Project	<b>IEEE 802.16 Broadband Wireless Access Working Group</b> < <a href="http://ieee802.org/16">http://ieee802.org/16</a> >	
Title	<b>P802.16h Working Document structure and purpose clarification</b>	
Date Submitted	<b>2006-09-28</b>	
Source(s)	Paul Piggin NextWave Broadband Inc. 12670 High Bluff Drive San Diego CA 92130 USA	Voice: 1 858 480 3100 Fax: 1 858 480 3105 <a href="mailto:ppiggin@nextwave.com">ppiggin @ nextwave.com</a>
Re:	Working Group Review of Working Document IEEE 802.16h-06/015r1	
Abstract	This document proposes a revised structure of the P802.16h Working Document.	
Purpose		
Notice	This document has been prepared to assist IEEE 802.16. It is offered as a basis for discussion and is not binding on the contributing individual(s) or organization(s). The material in this document is subject to change in form and content after further study. The contributor(s) reserve(s) the right to add, amend or withdraw material contained herein.

# P802.16h Working Document structure clarification

Figure 1: Representation of the suggested Working Document structure.

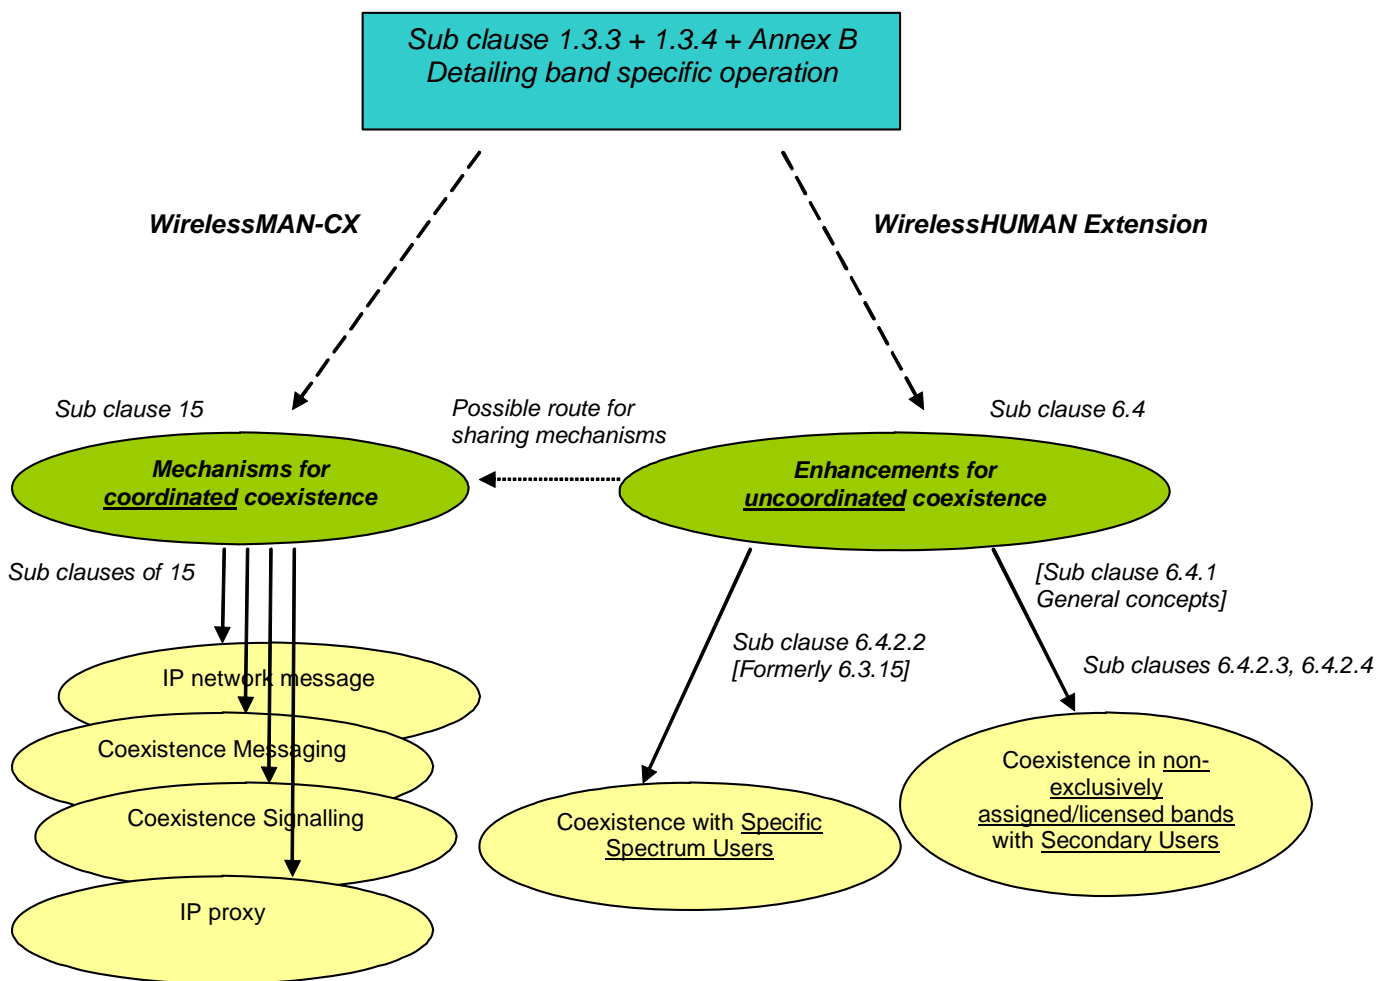
The suggested document structure is shown diagrammatically in Figure 1.

Per the definitions proposed below in this contribution, Clause 15 of [1] provides mechanisms of a coordinated nature. Subclause 6.4 of [1] addresses uncoordinated mechanisms. Contribution C802.16h-06/074 [5] proposes enhancements to those uncoordinated mechanisms. Contribution C802.16h-06/073 provides a summary of the band-specific operational requirements to be added to subclause 1.3.3 and Annex B. C802.16h-06/072 simply provides the definition of additional terms.

**Figure xyz1** Link level representation of DCS operation: (a) interference and remedial action at the BS, (b) interference reporting and remedial action at the MS/SS.

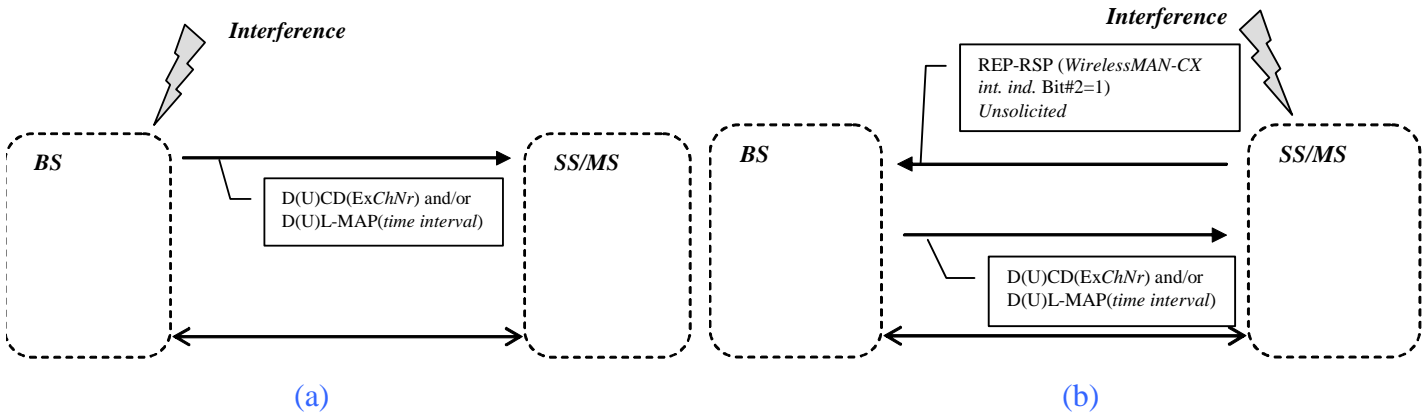
A general example of a DCS solution is provided in figure xyz1 in which interference detection provides agility in frequency and time to reduce the effects of the incident interference. Figure xyz1 (a) indicates the events that happen after interference is detected at the BS. Since the interference is deemed not to be an SSU, and therefore not protected by regulation, the DCS algorithm has the choice to either clear the channel (as would be required for the detection of an SSU) or find a less interfered area of the frame. The DCD/UCD, containing the ExChNr

(6.4.1.2), is used to make the channel change, while the DL-MAP/UL-MAP provides a change of location in the frame. A similar procedure is followed for interference detection at the SS, illustrated in figure xyz1 (b), however in this case the REP-RSP, sent by the SS in an unsolicited manner, initializes the messaging undertaken by the BS.
